Rep No.B21039a

Fuji Electric FA Components
& Systems Co., Ltd.

Notification regarding Addition of Design Features and Change in Panel Sheet Material and Paint for F-MPC60G Series Multifunctional Digital Relays for High-voltage Power Receiving Applications

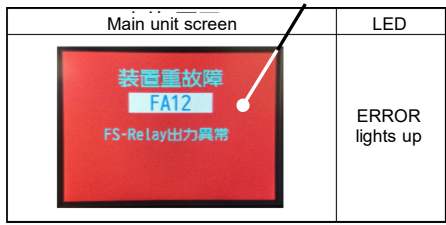
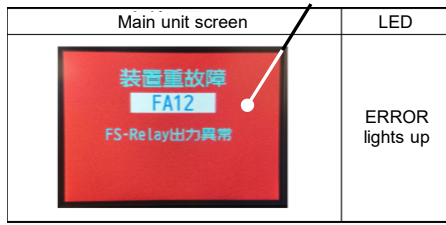
Product name	Multifunctional digital relays for high-voltage power receiving applications
Series name	F-MPC60G Series
Type	UM6□ (Common to all models)
Parts subject to change	<ul style="list-style-type: none"> • Software (additional features) ... The software version will be changed from V.1.□.□ to V.2.□.□. <ol style="list-style-type: none"> 1. Addition of accident waveform recording function 2. Addition of notification capability in case of equipment failure (RS-485 communication) 3. Addition of notification capability for circuit breaker on/off/trip (RS-485 communication and T-Link communication) 4. Change of equipment failure output at reset of clock IC • Hardware <ol style="list-style-type: none"> 5. Change of panel sheet material and paint
Details of the change	<ol style="list-style-type: none"> 1. The number of recording cycles can now be set from the operating point [protective action] when performing accident waveform recording. 2. In the event of equipment failure, the failure code indicating the details of the failure can now be read out via RS-485 communication. 3. Operating time measurement results during circuit breaker operation can now be read out via RS-485 and T-Link communication. 4. It is now possible to turn off the equipment failure output when the clock IC undergoes data reset. 5. Change of panel sheet material and paint manufacturer <p>For details, see the attachment.</p>

Reason for changes	To add the features required by the market and to improve procurability and productivity.
Date of the production change	Scheduled for products to be produced from May 2022
Attachment	Attachment: Addition of Features and Change in Panel Sheet Material and Paint for F-MPC60G Series Products
Notes concerning the changes	<p>This change will not affect product performance, but the version of the software being used will be changed. (We will not provide software changes for already delivered products.)</p> <p>[Version change]</p> <ul style="list-style-type: none"> • Applicable to low-voltage 3-phase 4-wire types (Type UM63FN-E□AK) <ul style="list-style-type: none"> V0 => V0A (Only 3 items will be changed. Items 1, 2, and 4 have been reflected in the specifications since the product launch) • Other than the above <ul style="list-style-type: none"> V1□ => V2
